**RE: Design Review for Delta Shores Regional Commercial Center Project Revisions (P14-025)**

WALKSacramento has reviewed the revised Delta Shores Regional Commercial project plans from February 23, 2015. We thank you for the opportunity to review and comment on this project. Our comments and recommendations follow:

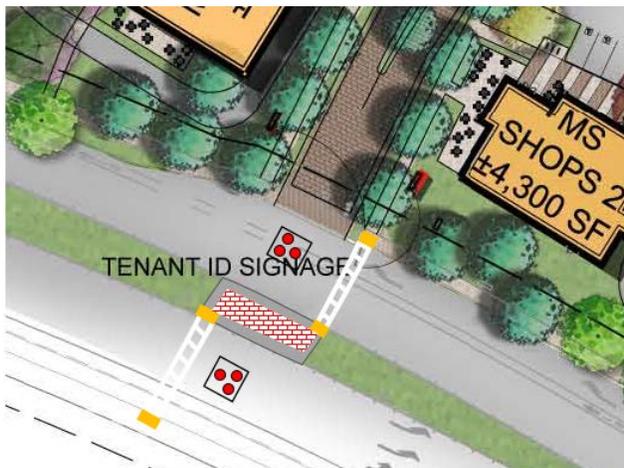
Considering the site plan as currently proposed by the applicant, it is crucial to provide a pedestrian crossing at the entrance to the Main Street area. With high density residential uses directly to the east and the more pedestrian oriented uses along Main Street, an at-grade crossing would improve access, safety and usability. WALKSacramento recommends that a two-stage staggered HAWK signal crossing be provided near the intersection of Main Street and Delta Shores Circle South.

HAWK signals provide safe and convenient crossings for pedestrians while allowing for less interruptions in traffic flow when compared to traditional traffic signals.<sup>1</sup> A two-stage staggered HAWK signal that only stops traffic in one direction at a time will provide a crossing that minimally disrupts traffic flow along Delta Shores Circle South. The first stage of the Main Street crossing would be near the north side of the Main Street entrance leading onto the median island.<sup>2</sup> This stage would only stop southbound traffic. The second stage of the crossing would start further south on the median island in line with the south side of the Main Street exit. This crossing would provide access between the median island and the residential uses to the east and only stop northbound traffic. See the following rendering for reference:
